APPENDIX 127C

UNITIZATION PROCEDURES FOR BOXED AMMUNITION AND COMPONENTS ON 4 - WAY ENTRY PALLETS

CORD, DETONATING, PACKED VARIOUS QUANTITIES PER WOODEN BOX, UNITIZED 6 BOXES PER 40" X 48" PALLET; APPROX BOX SIZE 26" L X 24% W X I4% H

REVISION NO. 1, DATED JANUARY 1984, CONSISTS OF:

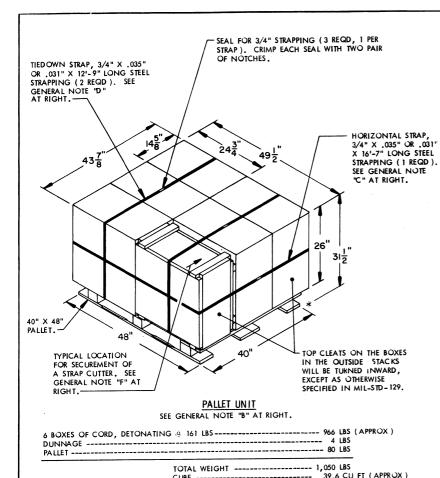
- 1. CHANGING BOX WEIGHT AND DIMENSIONS.
- UPDATING DRAWING FORMAT TO CONFORM WITH NUMBER 1 ABOVE.
